SITE DEVELOPMENT PLAN FOR HONOR CHARTER SCHOOL

PCD FILE NO. PPR2615

V2_Site Development Plan.pdf Markup Summary

SITE DEVELOPMENT PLAN

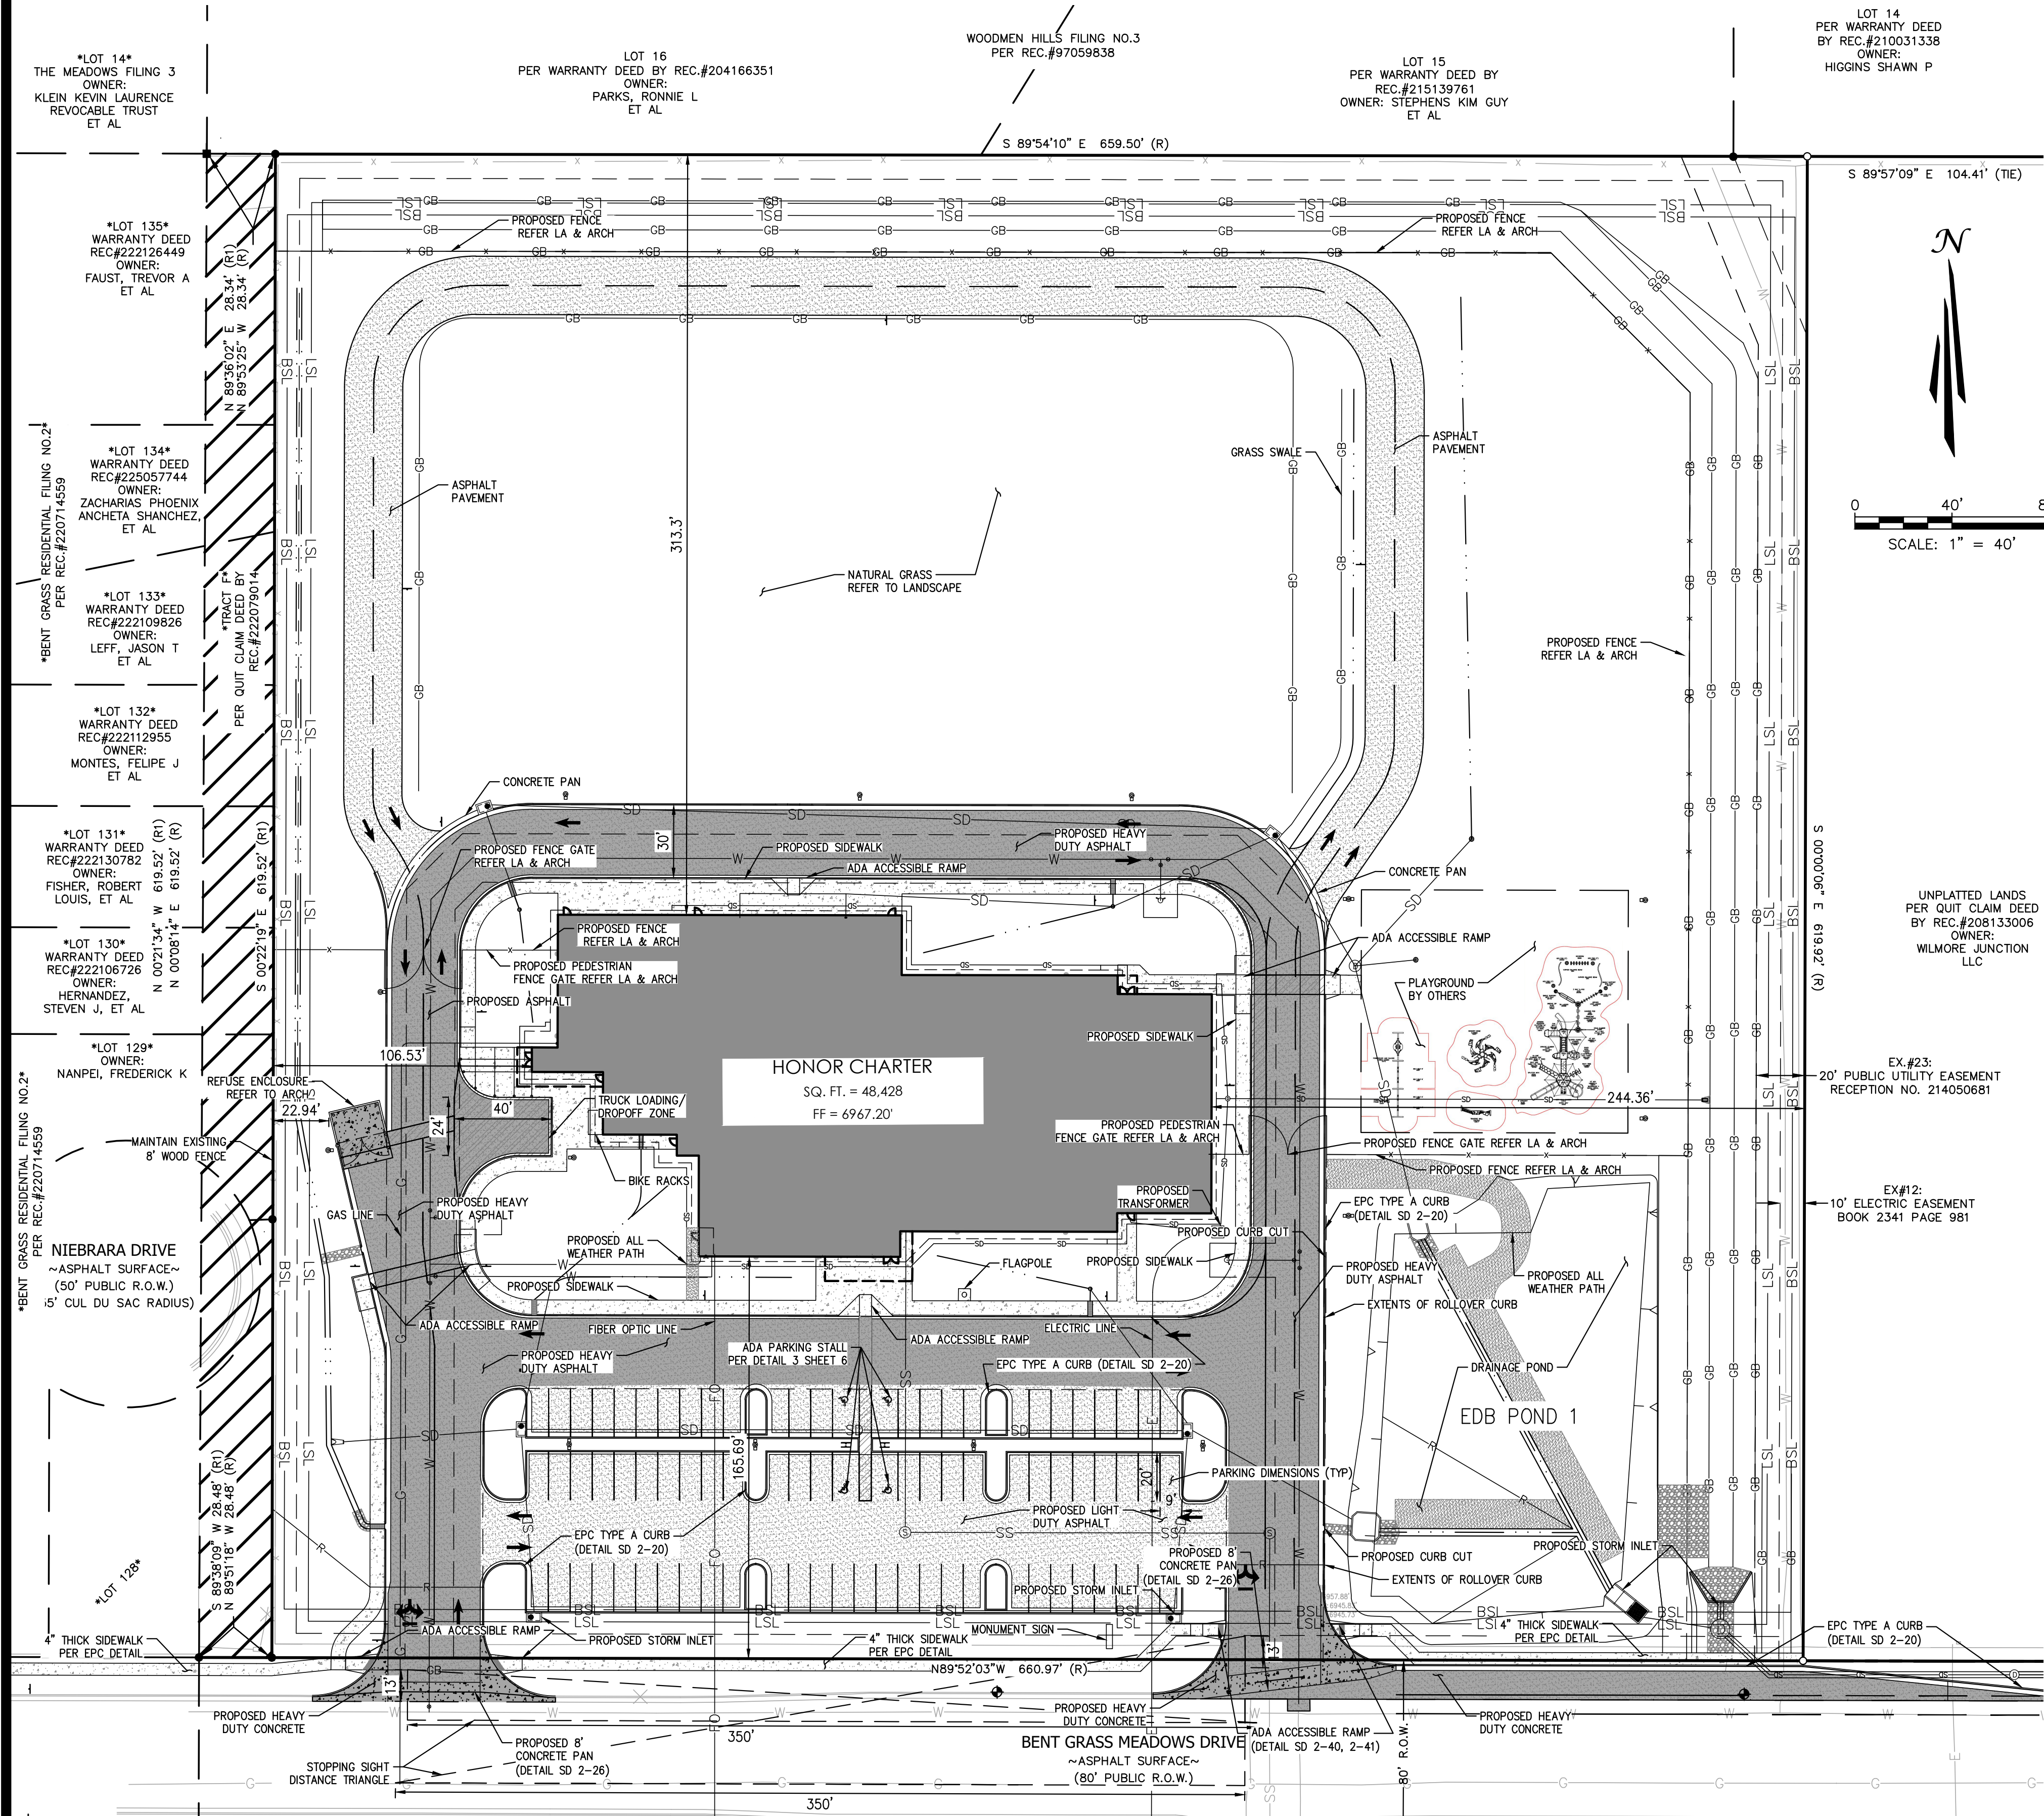
provide the actual setback numbers and 15' buffer at north and west property line required and line.
